Company	Trenz Electronic GmbH
PCN Number	PCN-20210614
Title	TE0784-01 eMMC Change and Product Update
Subject	BOM change
Issue Date	2021-10-25

2.1 #1 Change eMMC (U15) from IS21ES08G-JCLI to SDINBDG4-8G-XI2

old	new
IS21ES08G-JCLI	SDINBDG4-8G-XI2

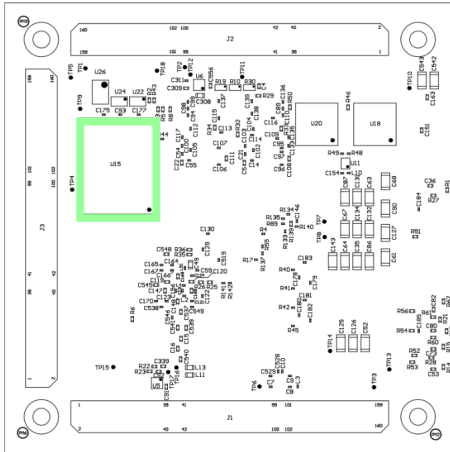
Type: BOM change

Reason: Distributor informed about unforeseeable immediate EOL of parts. No official documents from manufacturer are available. No LTB, already confirmed orders were cancelled by distributor/manufacturer.

Impact: None. Replacement has same capacity as used on corresponding affected variant. Reference designs for vivado versions 2019.2 and 2020.2 were tested and work properly without any changes.

Locate eMMC (U15) on bottom side of PCB:
